Pinehaven Structural Works - Technical Review - Flooding

Peer Review

Prepared for Greater Wellington Regional Council
Prepared by Beca Limited

2 December 2019

Figure 4-3 Hydrological catchments

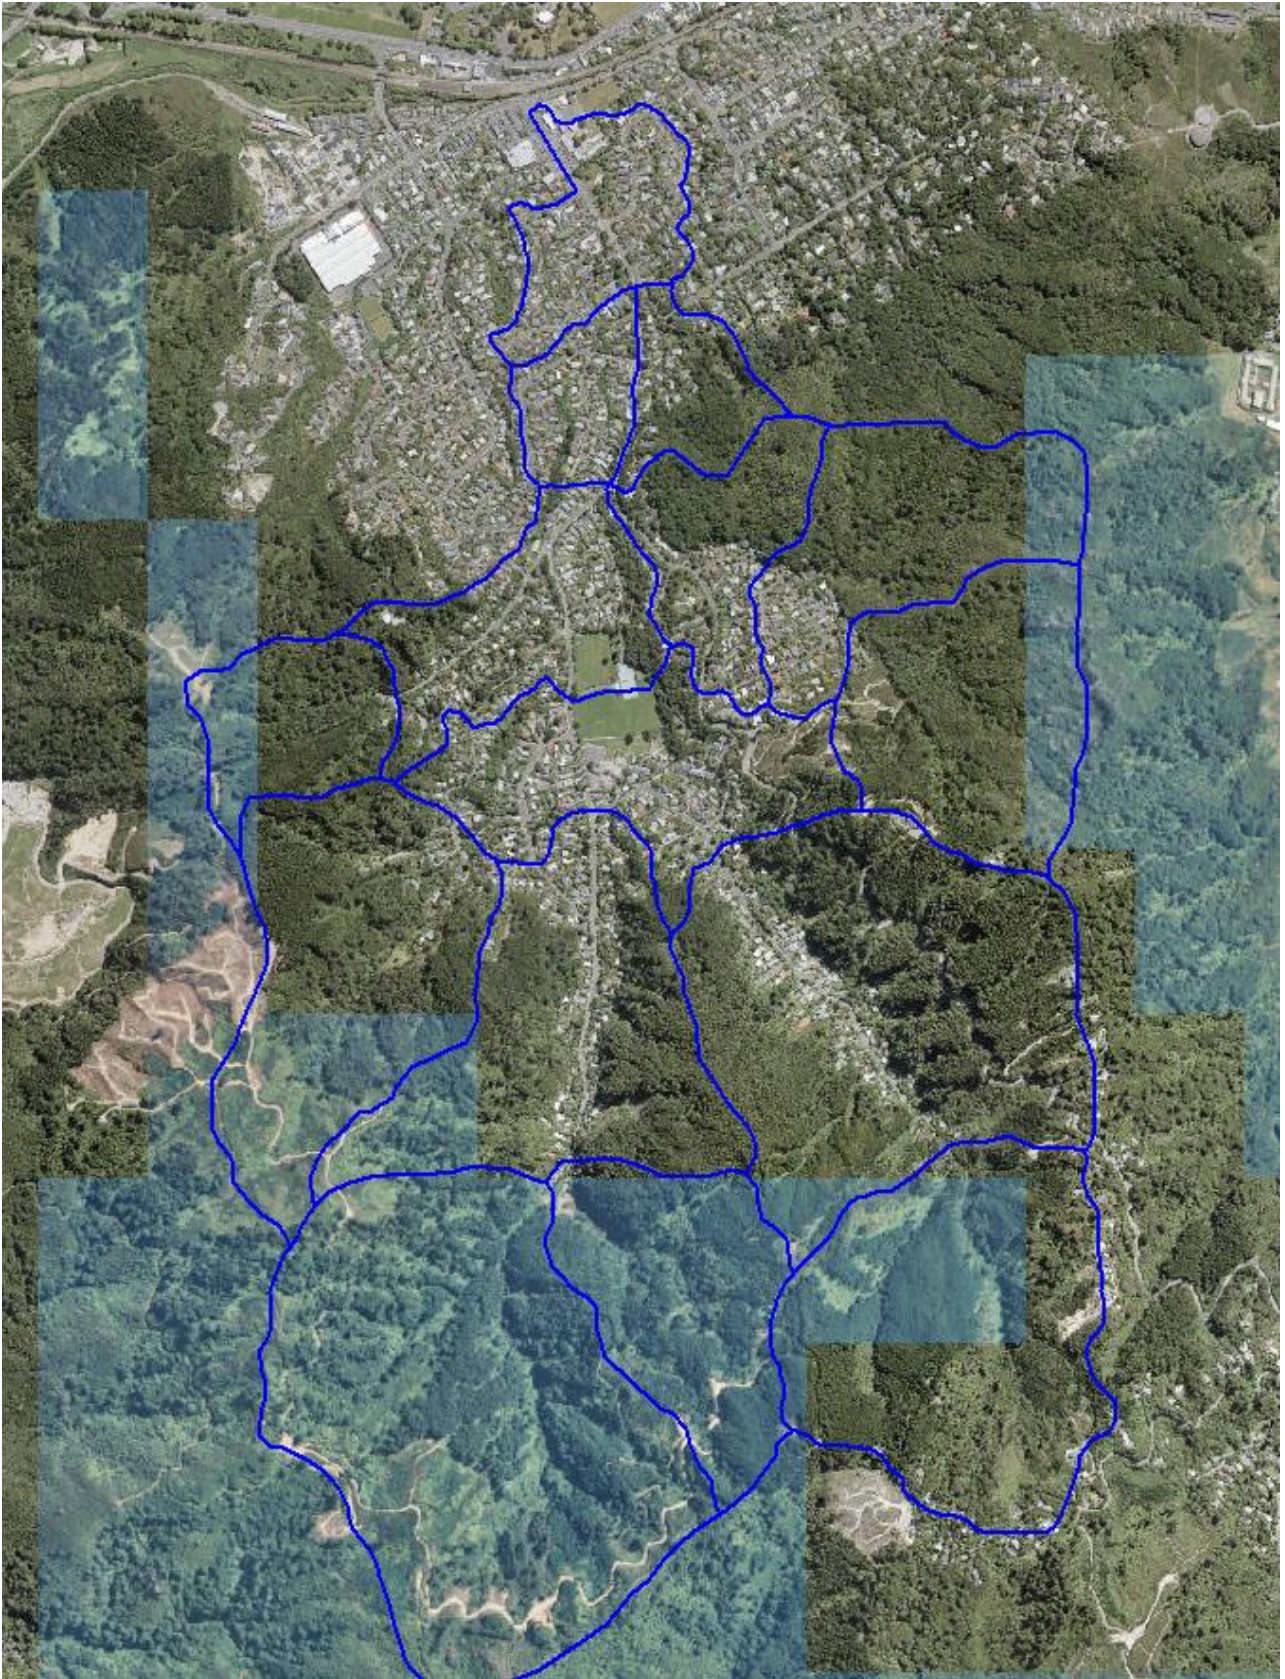
<p>Catchments</p>	<p>Figure 4-3 shows the catchments used in the hydrological modelling. The catchments range from 0.735km² to 0.1397km². Catchments of this size are large for a detailed design model, but given the lack of detail in the hydraulic model (e.g. no stormwater pipe network) these are appropriate. Based on the 2D surface supplied with the model they appear to be delineated appropriately.</p>	<p>Findings and comments on catchment size acknowledged. Agreement with appropriateness of catchment size and delineation, based on resolution and detail of base model.</p>	<p>CLOSED</p>	<p>1</p>	<p>Yes</p>

Figure 4-4 Changes to DEM – Design model on the left and Base model on the right

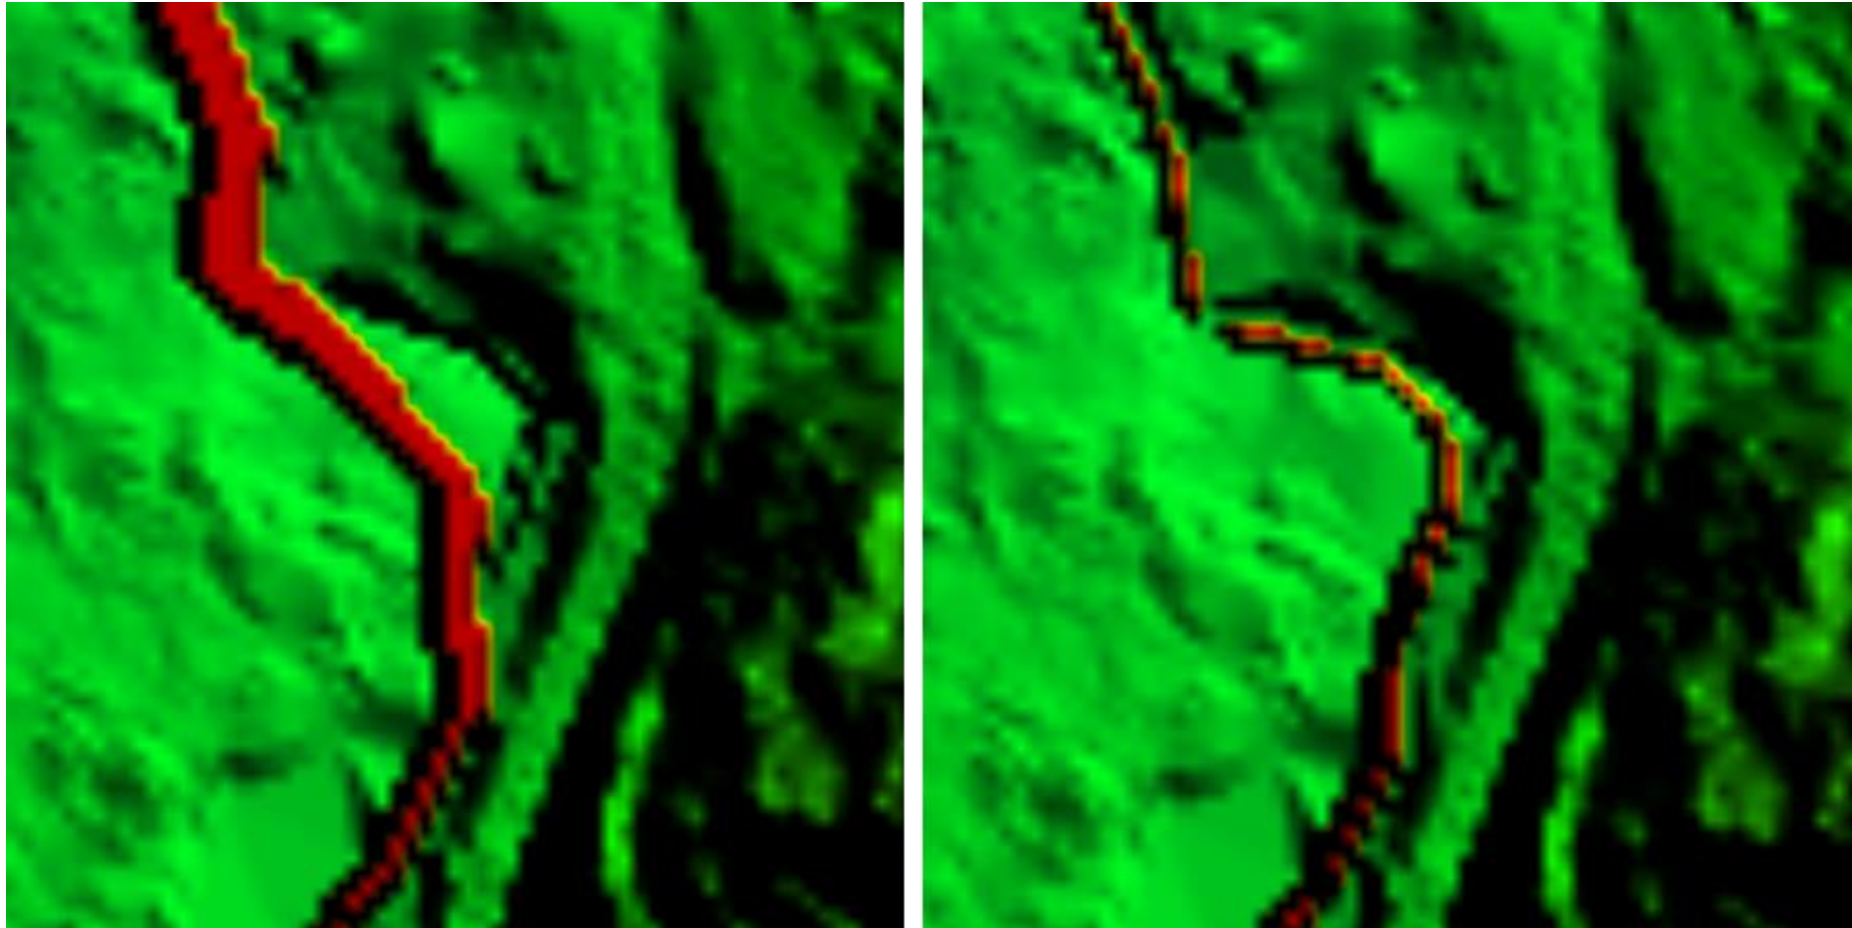
Item Checked	Findings & Comments	Modeller's response	Reviewer close out comments	Rating	Fit for use
MIKE21					
Grid/Mesh	<ul style="list-style-type: none"> Model includes two gridded surfaces; representing Base (pre) and Design (post) proposed stream works Model updated with 2013 LiDAR The model uses a grid of 2x2 m. This is an appropriate level of detail, and more refined than the 5x5 m grid reviewed in 2015. The extent of the grid is such that the flood plain is covered. This is confirmed by the 100-year ARI results showing that that no water is glass-walling at the edges of the grid. The Pinehaven Stream between Pinehaven Reserve and Whitemans Rd has been blocked out of the grid where M11 is present to prevent double counting. The blocking out has been increased in areas of stream widening (this matches changes to the M11 cross-sections) as indicated by the red areas in Figure 4-4. The stream centreline and mesh blockout at 28 Blue Mountains Rd between the Design model and Base model is slightly different. 	Agreement with findings and comments noted.	CLOSED	0	Yes

Figure 4-8 100-year ARI long-section

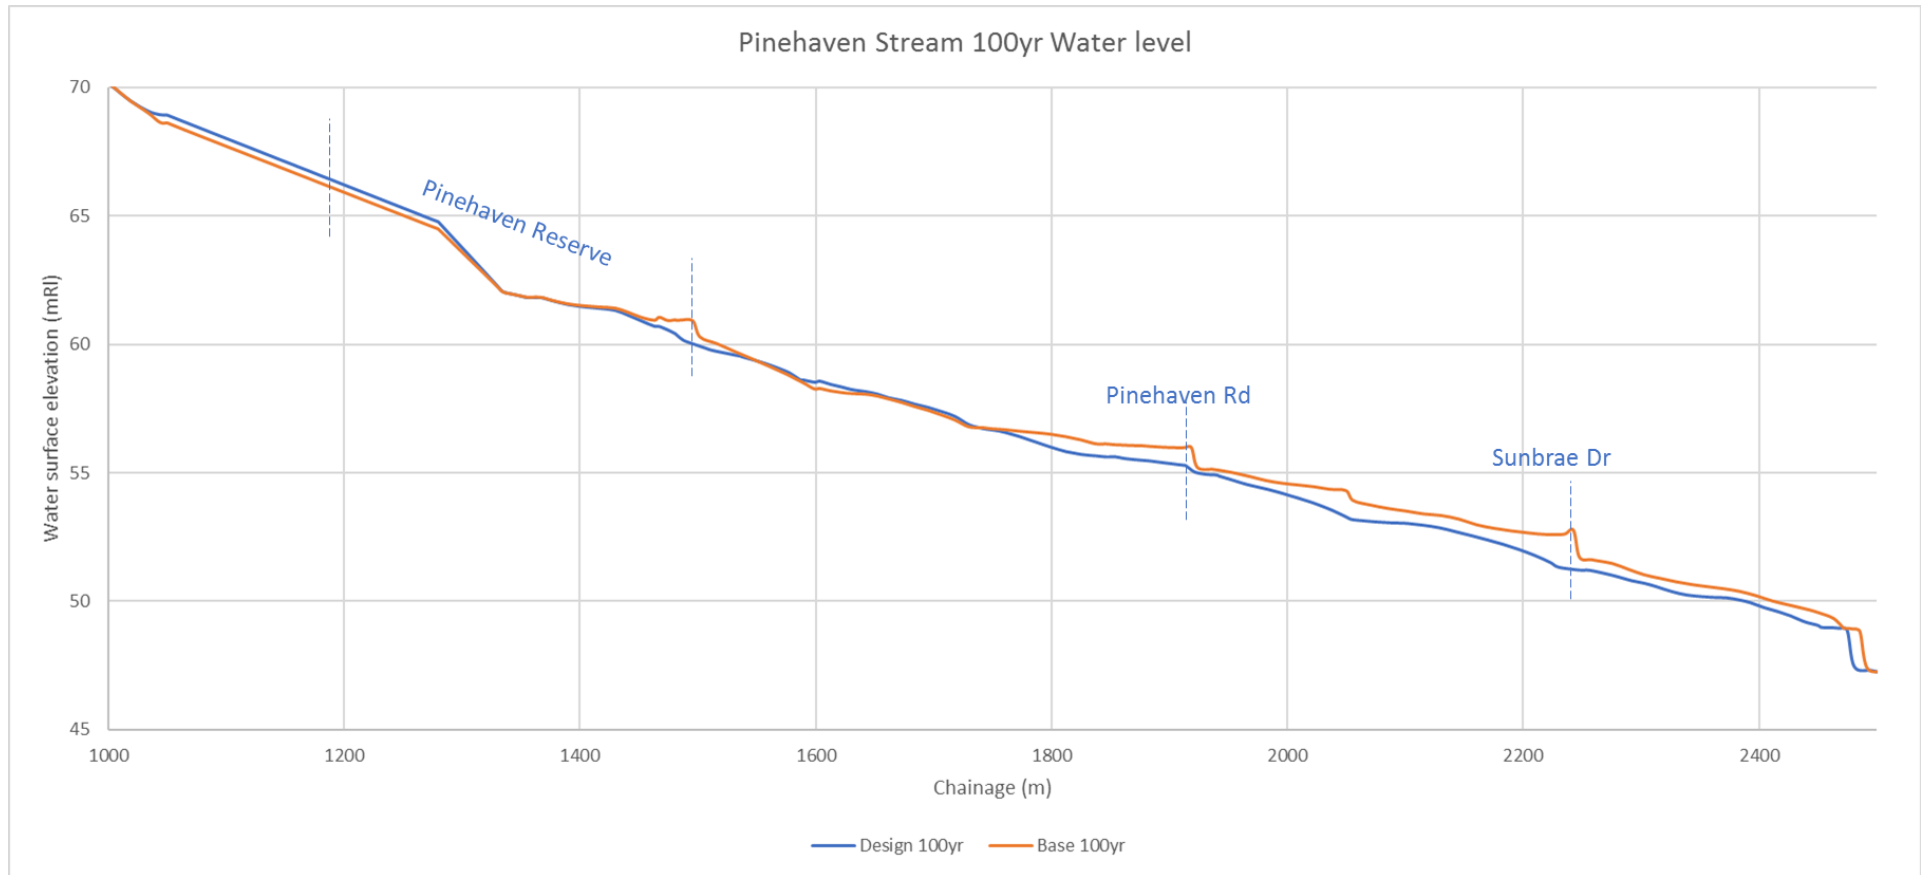
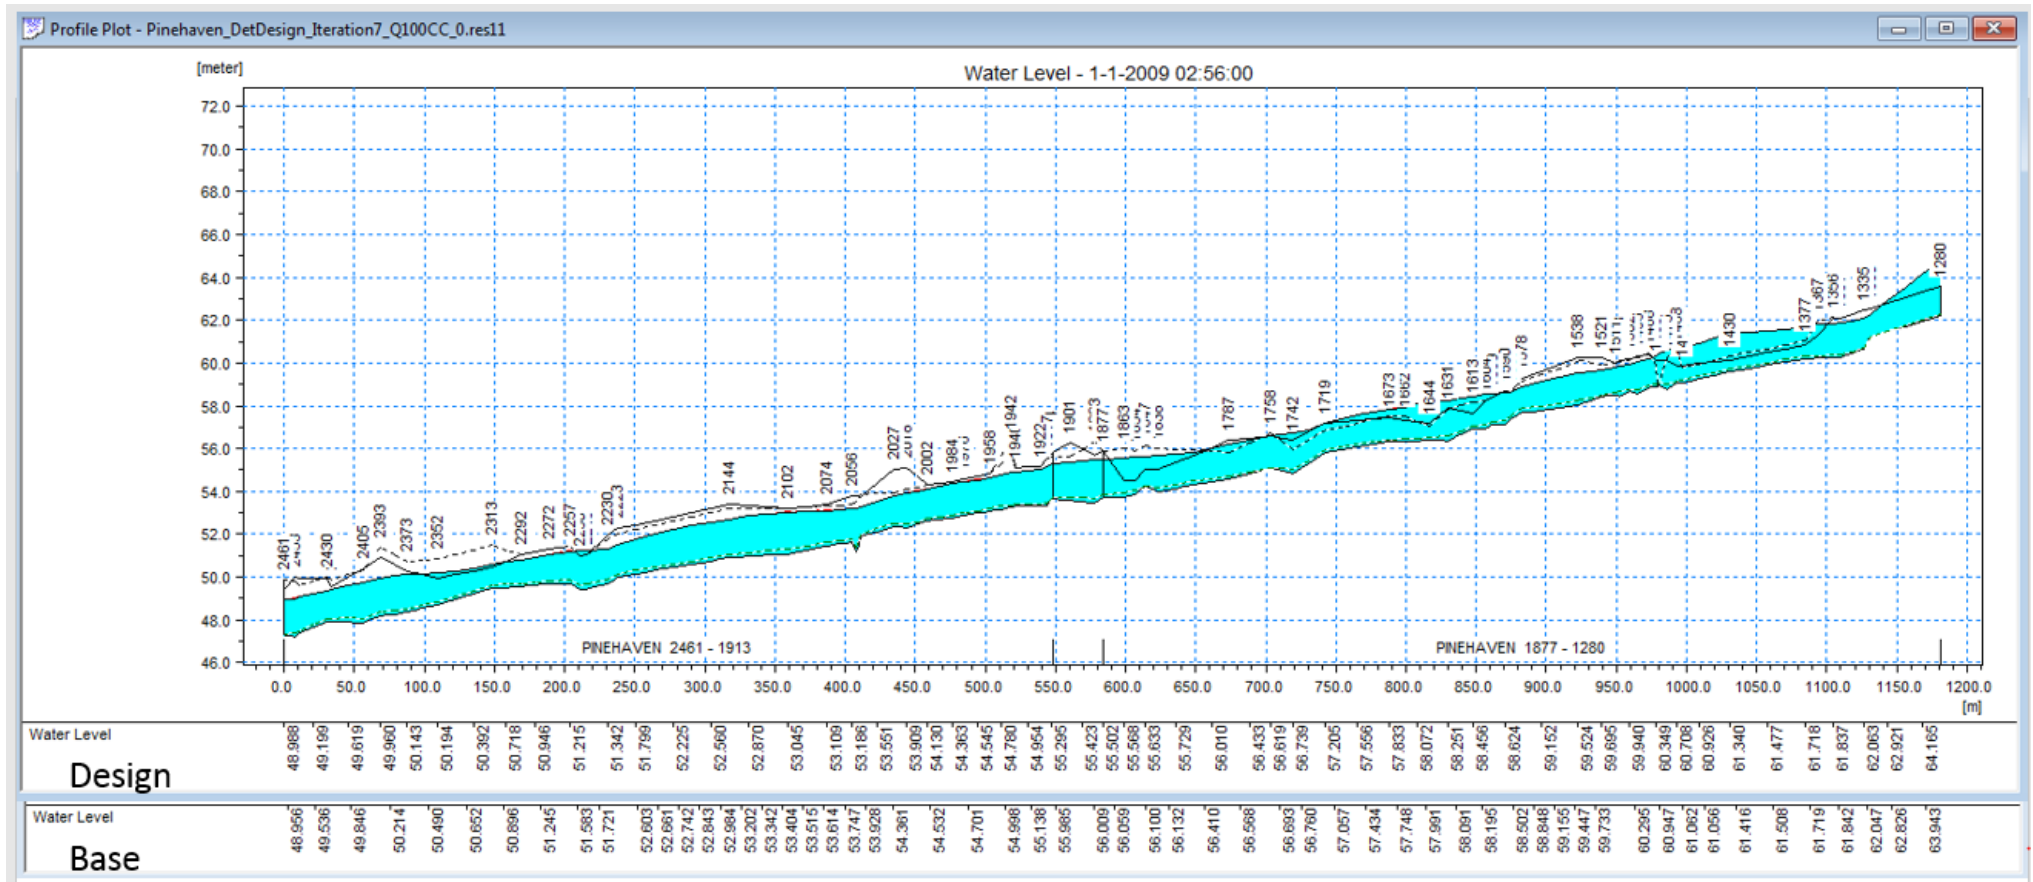
MIKE11 Water levels	The HGL plot in Figure 4-8 and Figure 4-9 shows that the 100-year ARI event water levels are reduced in most stretches of the stream due to the stream widening and larger culverts. Two sections have increased in water level. <ul style="list-style-type: none"> The piped section in and upstream of Pinehaven Reserve. This is unexpected, as we assumed that there were no changes in this reach and do not expect it to be affected by the stream works. <u>Is the modeller able to explain this?</u> A short section at Ch.1600. Near 2A Freemans Way (as stated in the executive summary of the Flood Hazard Assessment report) 	The piped section in Pinehaven Reserve was not checked because it is outside the area of main channel works. Differences in water level do not affect containment within the channel (as this is a piped section) or habitable floor flooding (as the area is a reserve). Near 2A Freemans Way there are no channel works proposed. The differences are thought to be due to a combination of channel works upstream directing more flow into this reach instead of entering the Birch Grove area and a slight change in timing of the flood peak.	Uncertainty over the cause of the raised water levels through the reserve is not expected to adversely affect the relative effects of the stream works, and so does not materially affect the 'fit for use' categorisation. However, the Reviewer notes that the issue is not resolved and so the issue will remain open OPEN	2	Yes

Figure 4-10 100-year ARI MIKE21 (2D) flood extents.

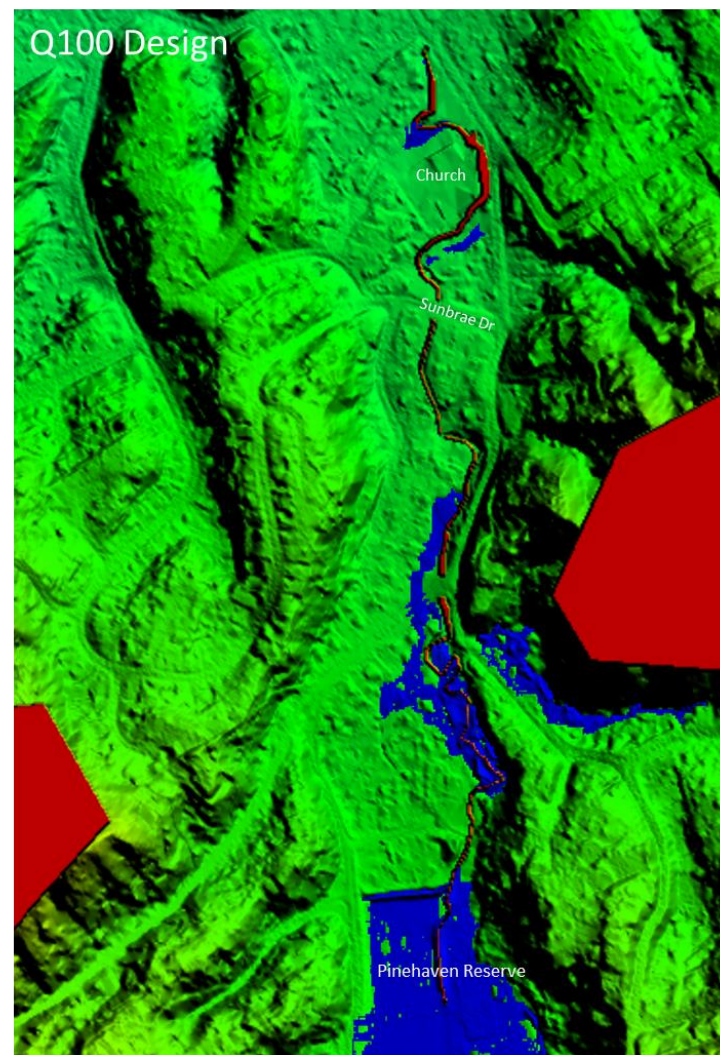
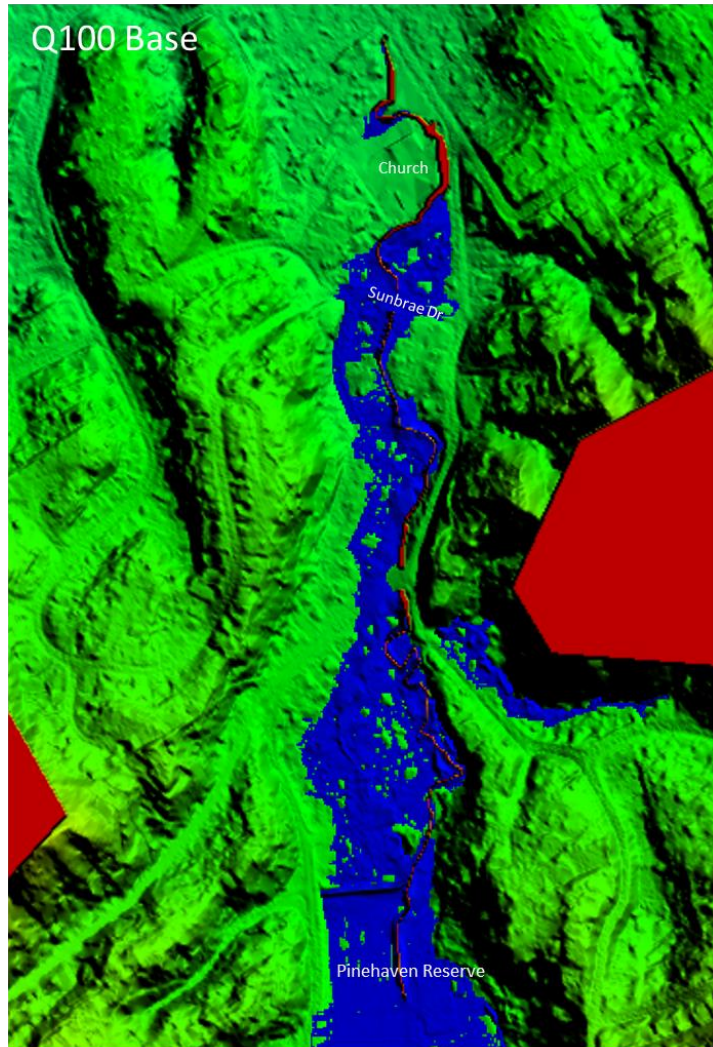
MIKE21	Downstream of Pinehaven reserve there is a significant reduction in flood levels. These are replicated in both the M11 water levels and the M21 results (Figure 4-10).	Noted; agreement with comment.	CLOSED	0	Yes
